ADDENDUM NO. 2

RE: Murray Hill Middle School Controls Upgrade (HCPSS Bid #053.23.B3)

FROM: Purchasing Office
Howard County Public Schools
10910 Clarksville Pike
Ellicott City, MD 21042
(410) 313-6723
(410) 313-6789 fax

E2.2

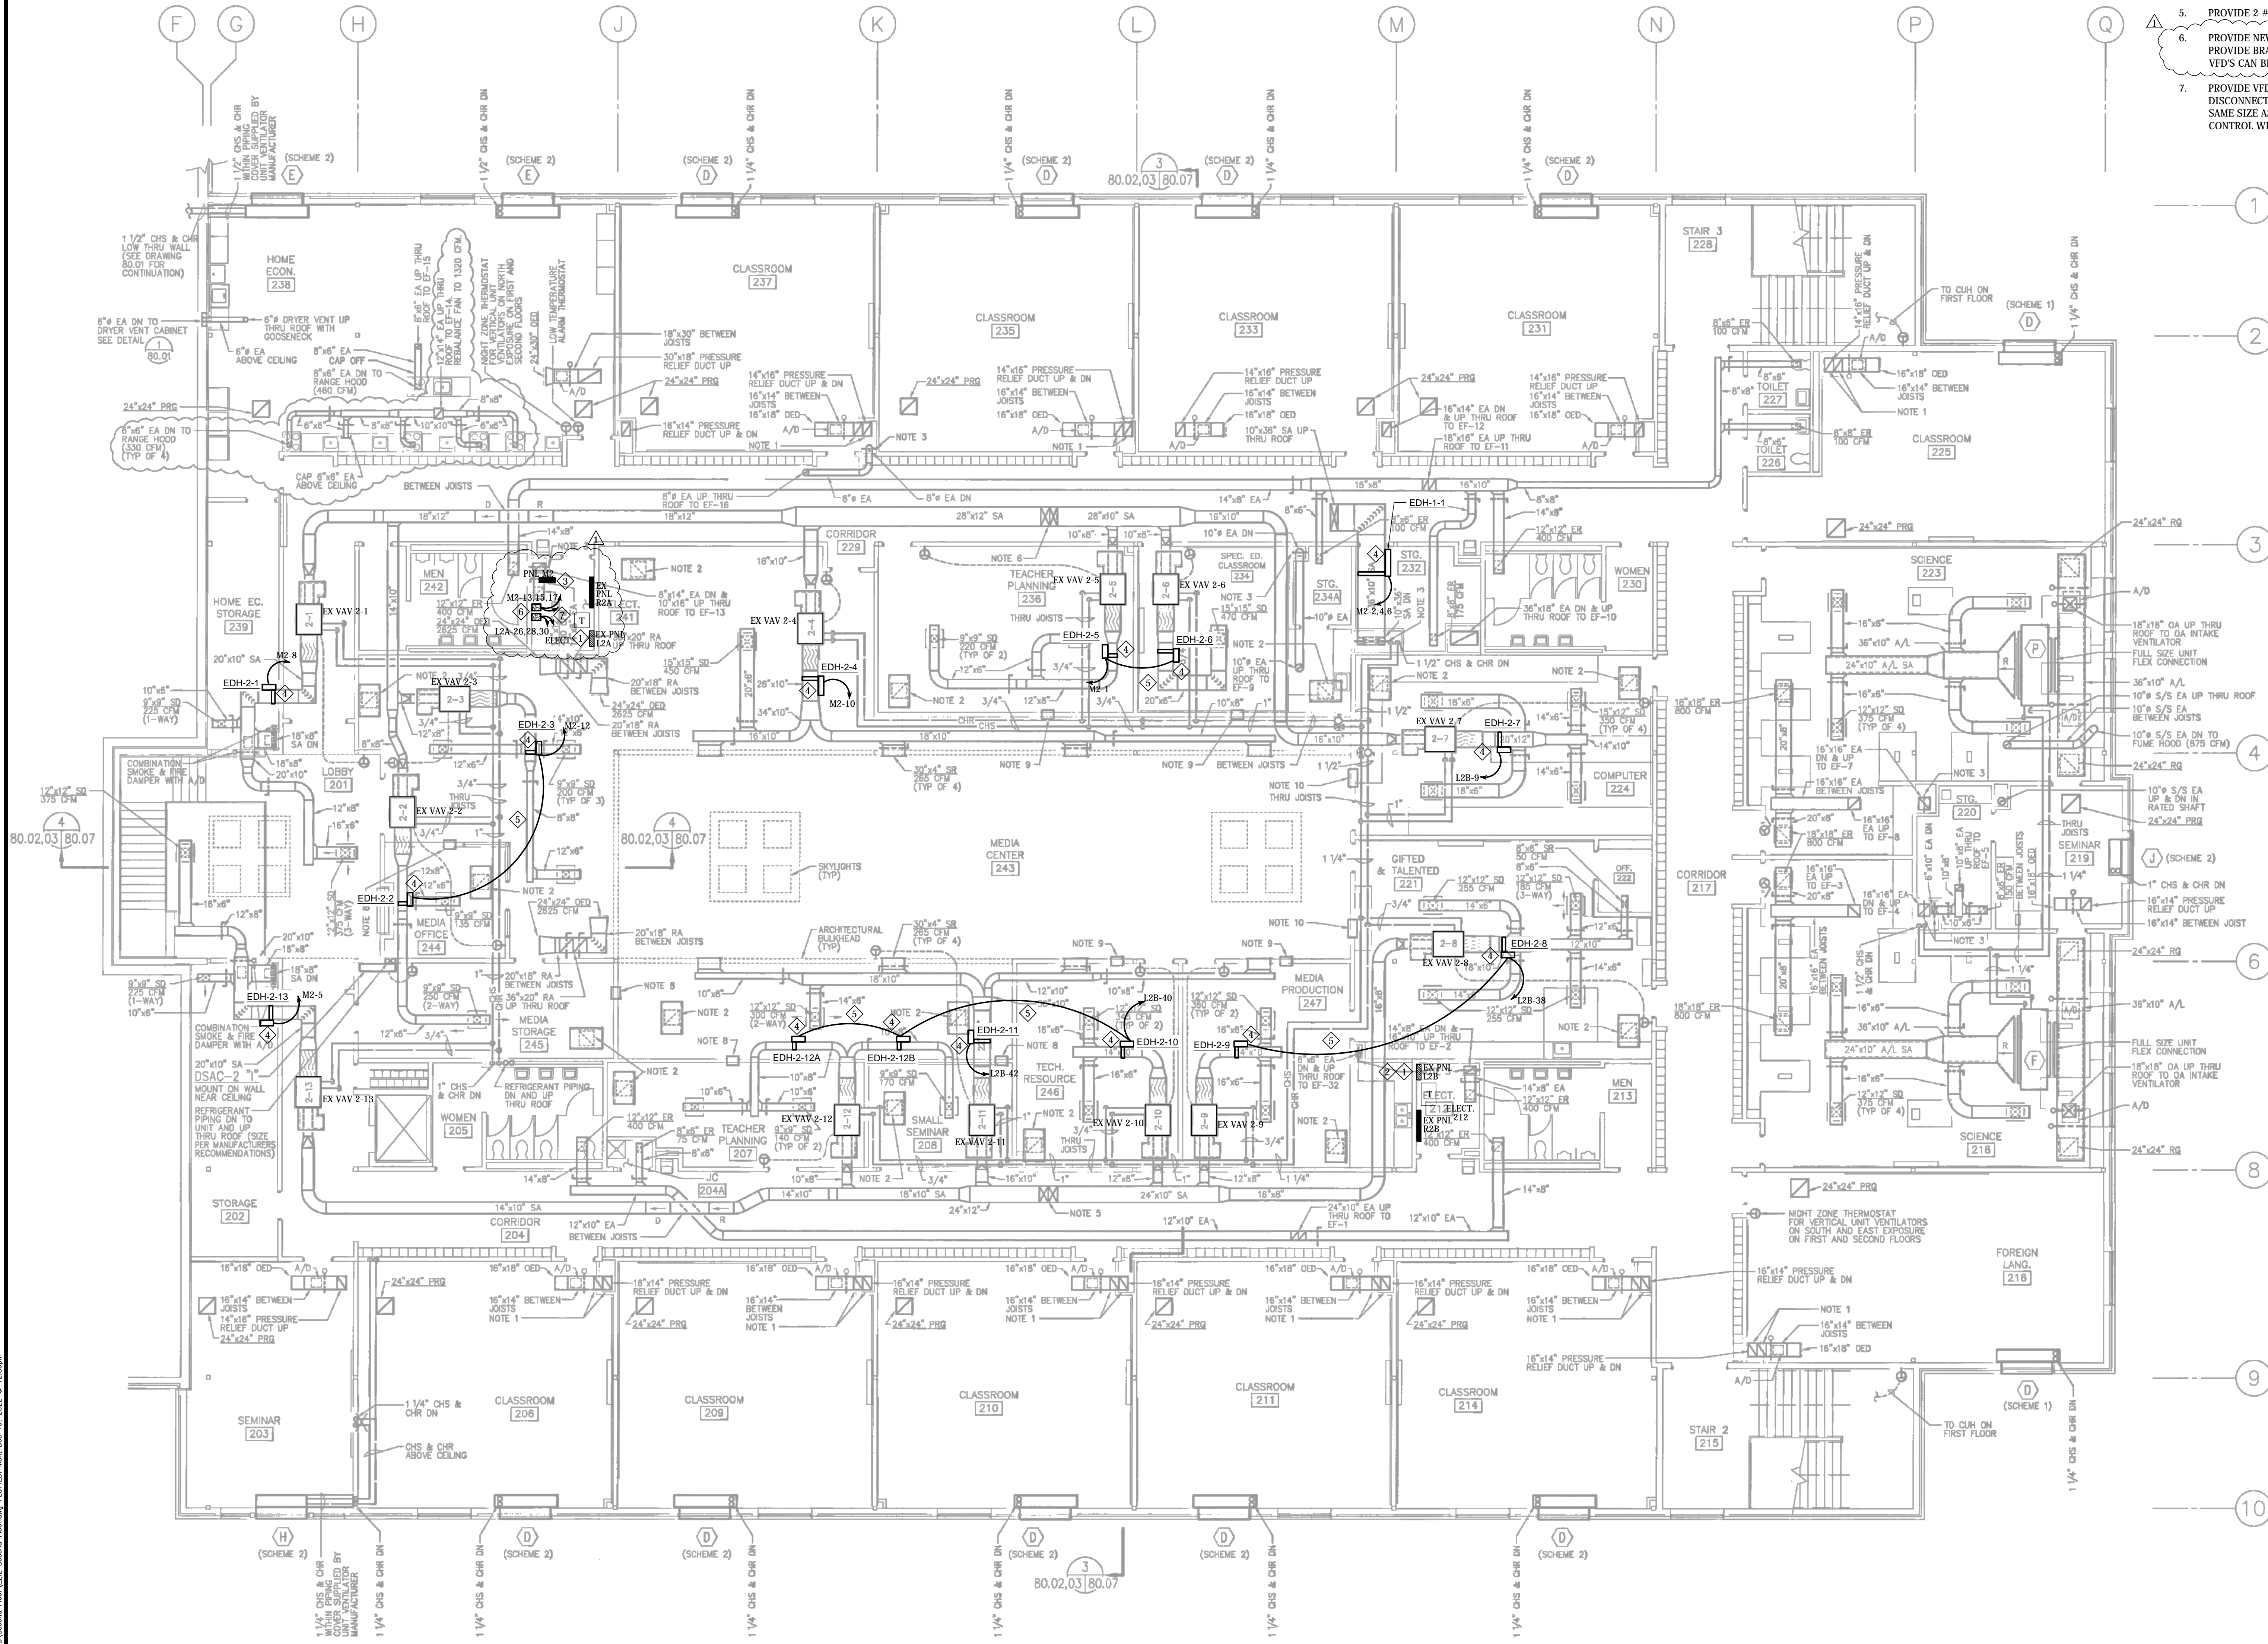
1. The Electrical Room 241 has very little wall space for the new panel M2 and the two new VFDs. Can the VFDs be located in or on the existing RTU #2? **Response: The Electrical Engineer has completed another site survey and has determined that there is enough space in the Electric Room 241. Refer to revised Electric Room layout on attached Drawing E2.2.**

1. **E2.2:**
 - a. Revised locations of Panel PNL M2 and VFDs.
 - b. Revised Special Note 6.
 - c. Added Drawing Note A.

- THE SPACE IN THE ELECTRICAL ROOM IS TIGHT. CONTRACTOR SHALL BE RESPONSIBLE TO MAKE SURE ALL THE NEW EQUIPMENT FIT IN THE EXISTING SPACE.
